Hazardous Waste Ground-Water Task Force

Evaluation of
B. H. S., Inc.
Wright City, Missouri

UPDATE OF THE HAZARDOUS WASTE GROUND-WATER TASK FORCE EVALUATION OF THE B.H.S., INC., WRIGHT CITY, MISSOURI, FACILITY

GROUND-WATER MONITORING EVALUATION

FIGURE 7. DESIGNATION OF WASTE MANAGEMENT AREAS

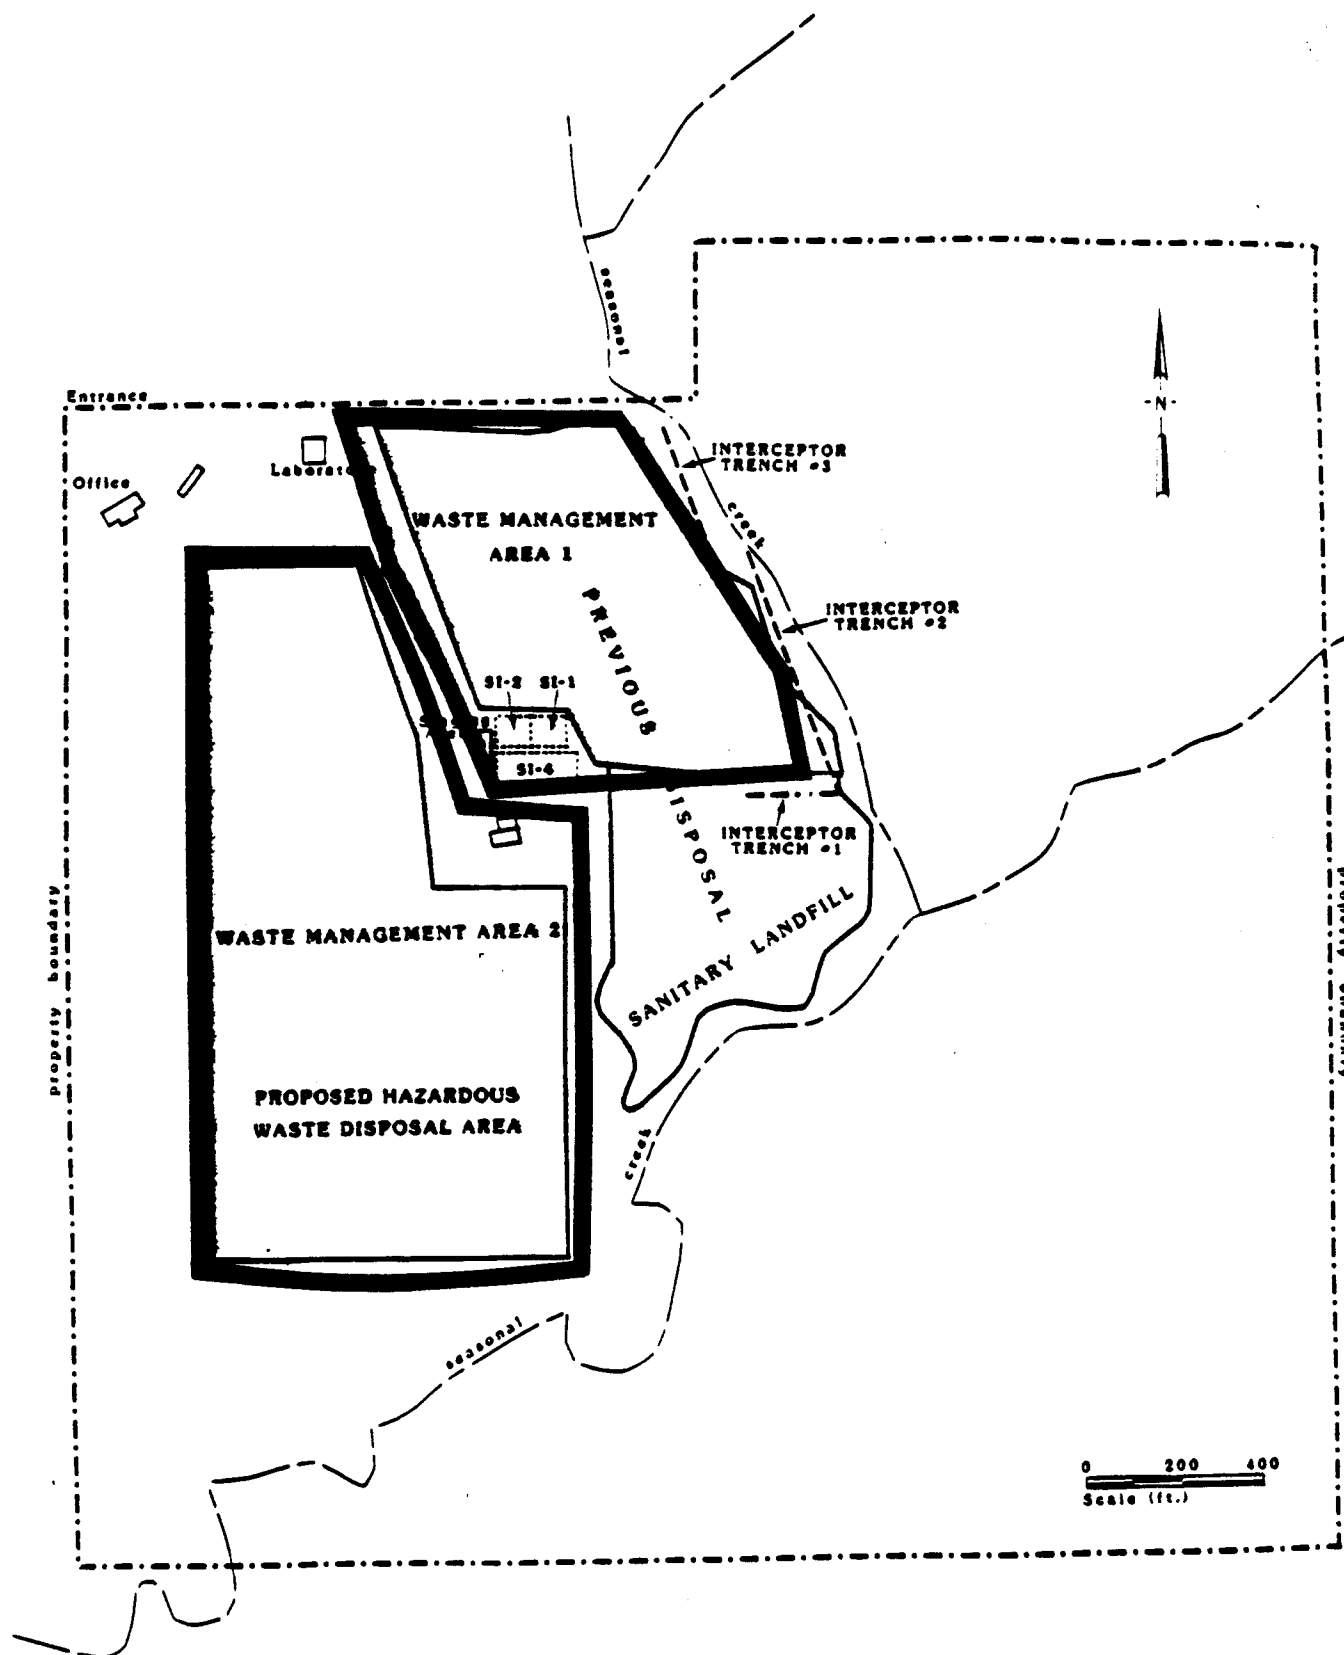
B.H.S. has divided the facility into two Waste Management Areas (WMAs) [Figure 7]. WMA1 includes Area 1 and surface impoundments SI-1, SI-2 and SI-4. WMA2 includes Area 2 and the storage and treatment areas. A Compliance Monitoring Plan for the areas has been proposed by B.H.S. and a proposed Detection Monitoring Plan and Corrective Action Plan were provided in the Part B application. Selected B series wells will serve as compliance points.

FIGURE C-2

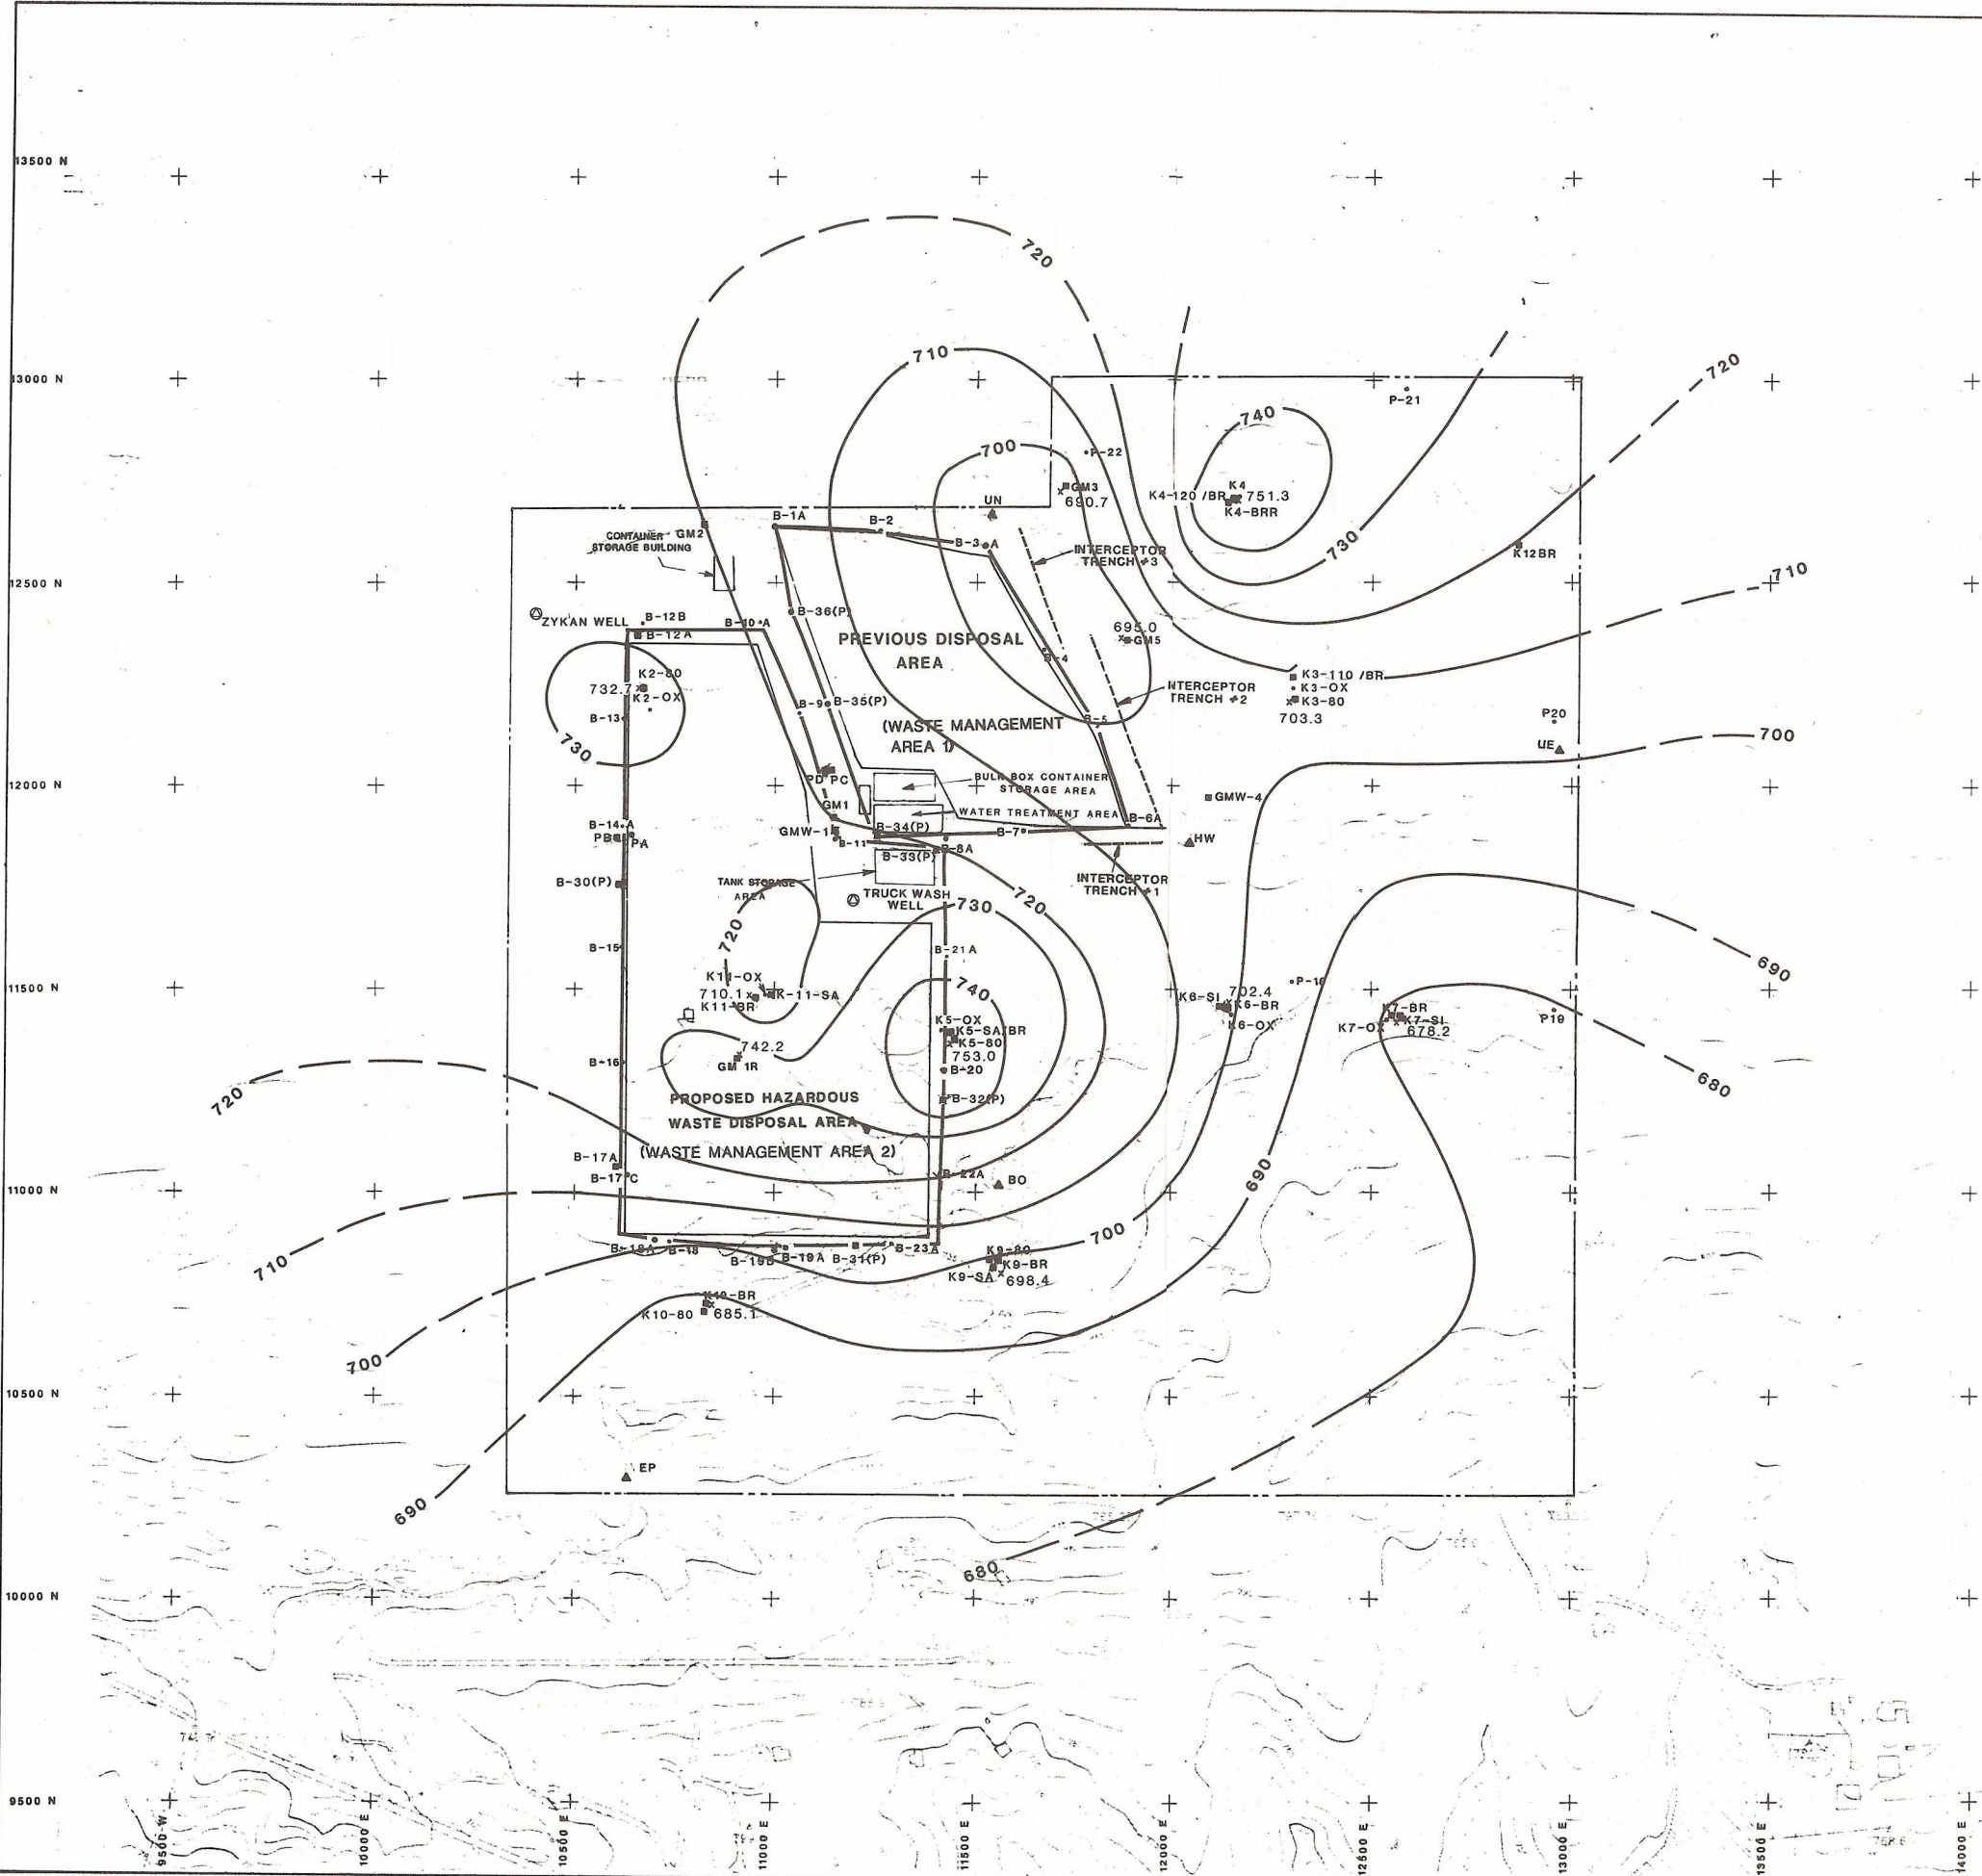
The simulated potentiometric surface map "A" Unit [Appendix C, Figure C-3] shows potentiometric contours as much as 20 feet above the ground surface. None of the piezometric surface maps generated by this model, with estimated or assigned values for this site, are acceptable.

FIGURE D-7

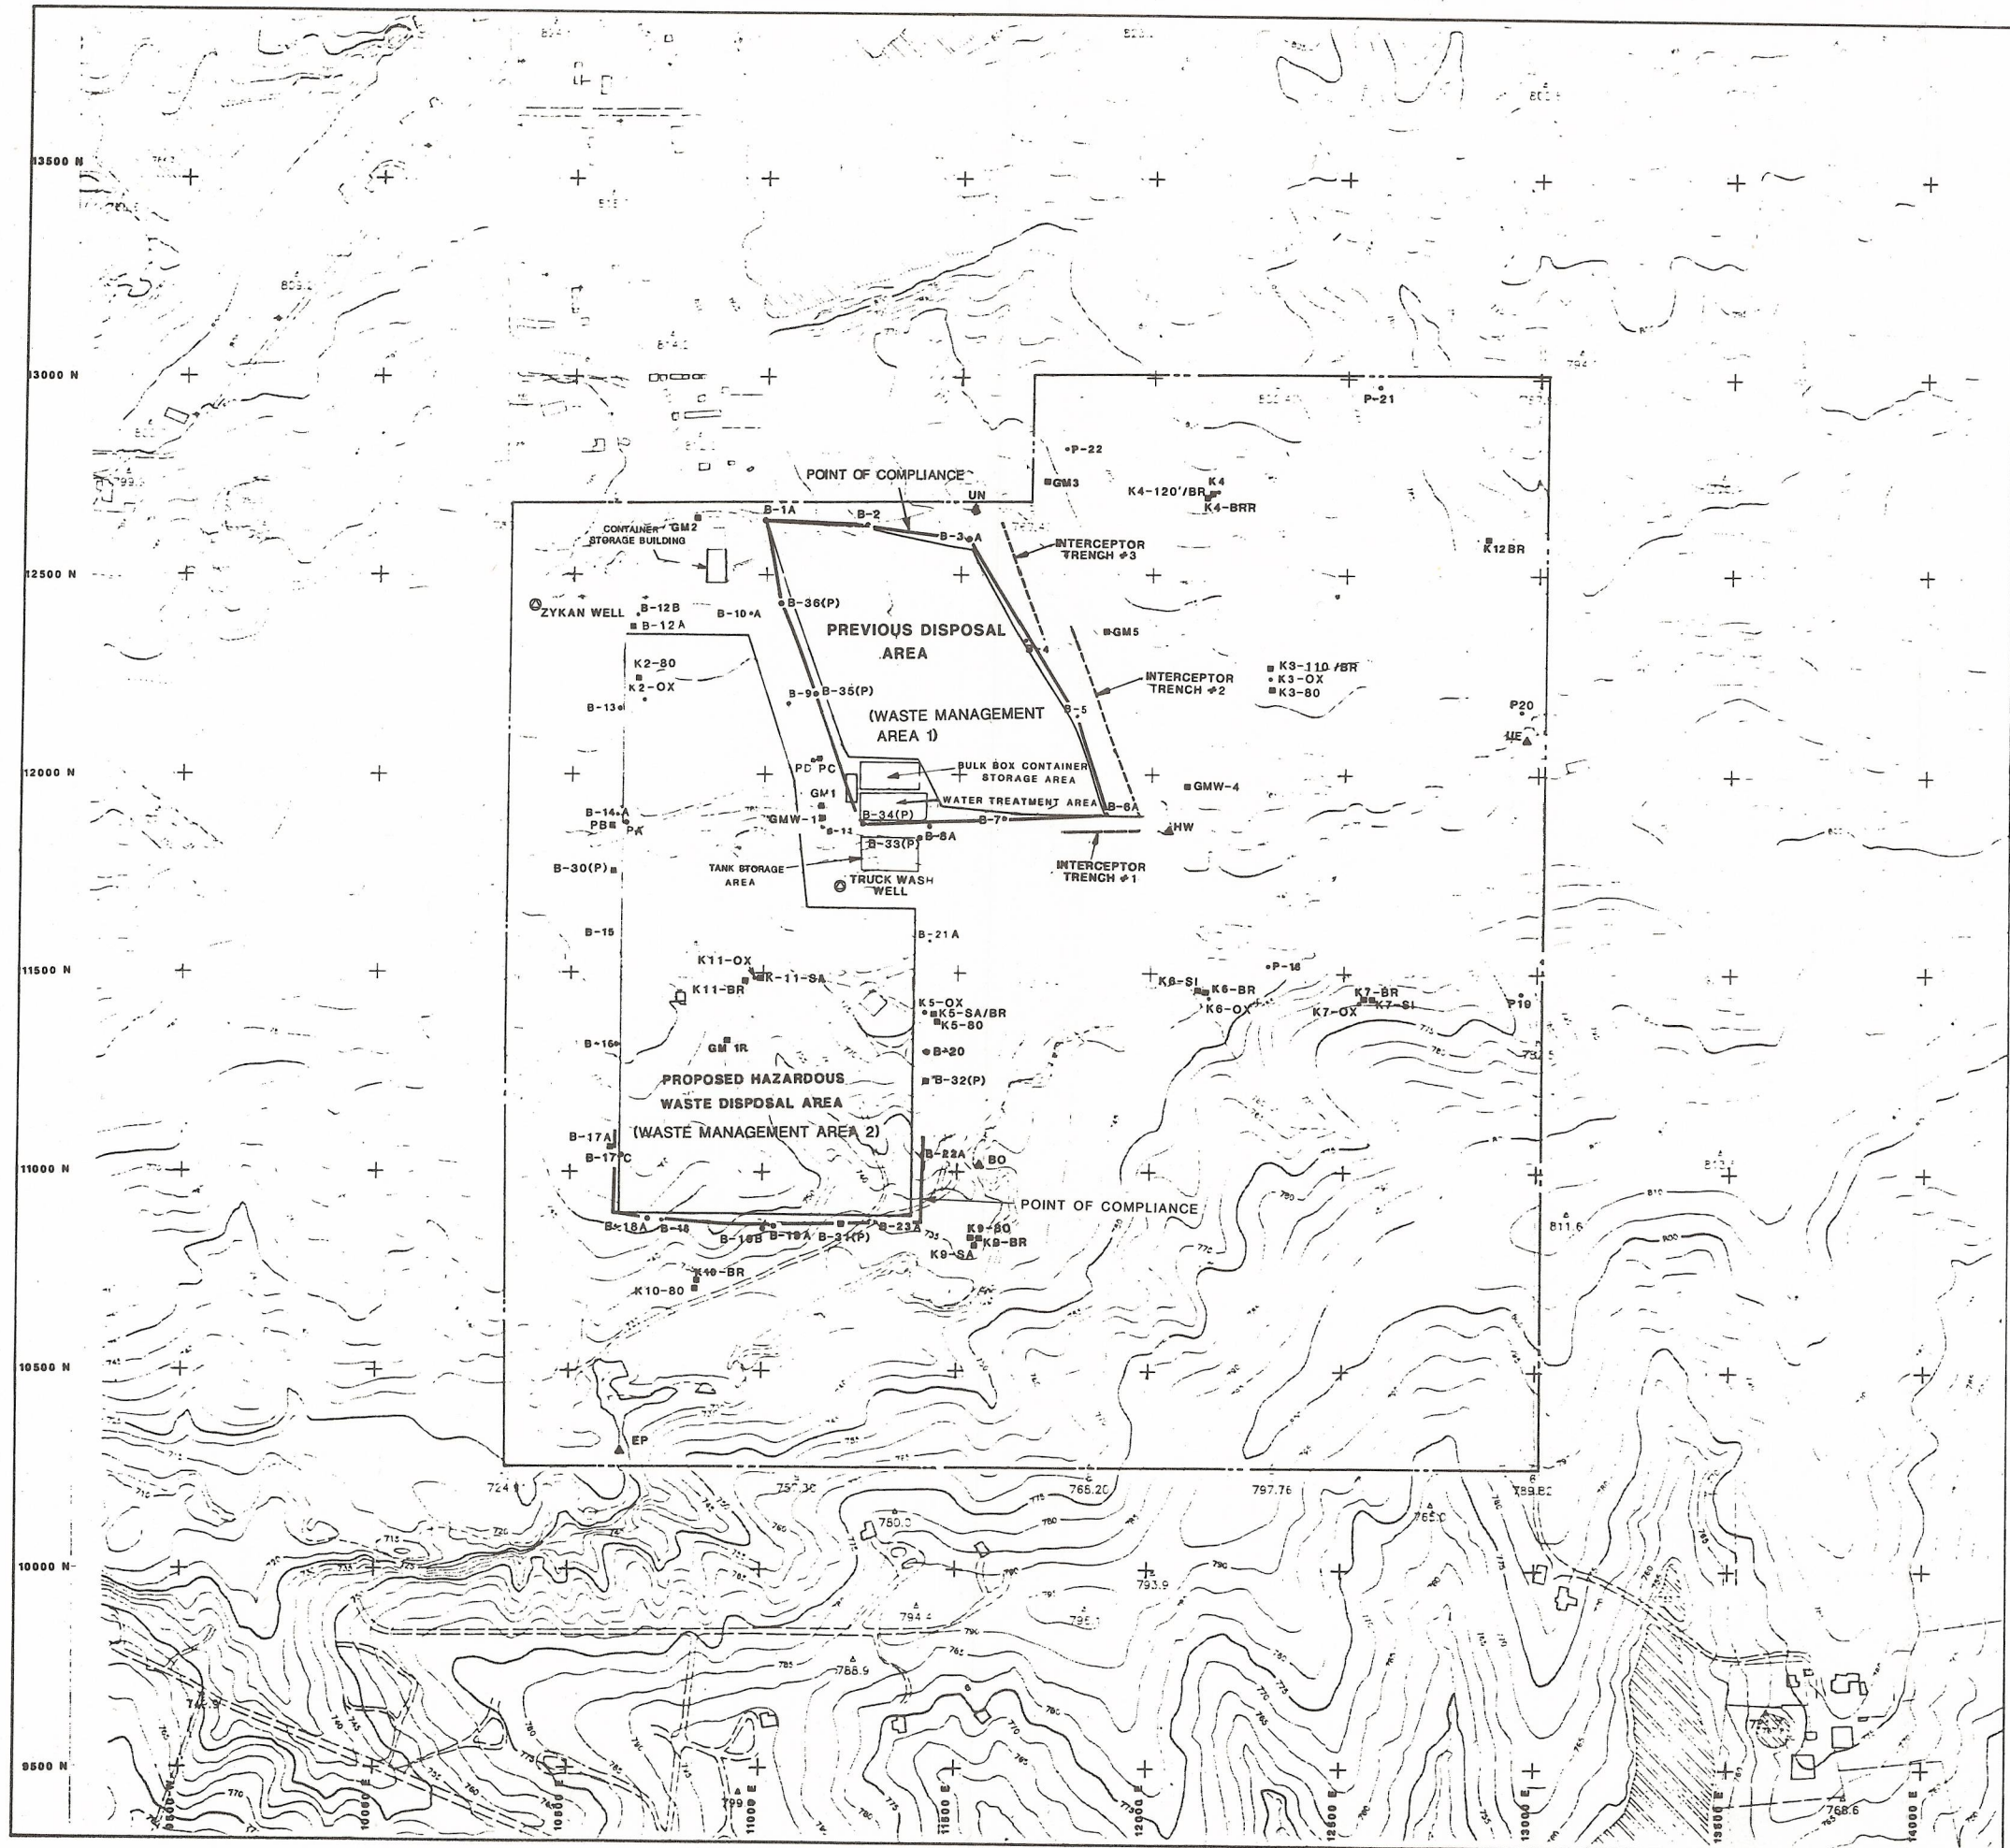
For WMA2, the point of compliance is the southern boundary of the proposed landfill [Appendix D, Figure D-7]. The sufficiency of the point of compliance proposed for WMA2 cannot be determined until a more thorough hydrogeologic site characterization is provided and a presentation is made to illustrate the effects of design, construction and operating practices on the ground-water flow patterns.
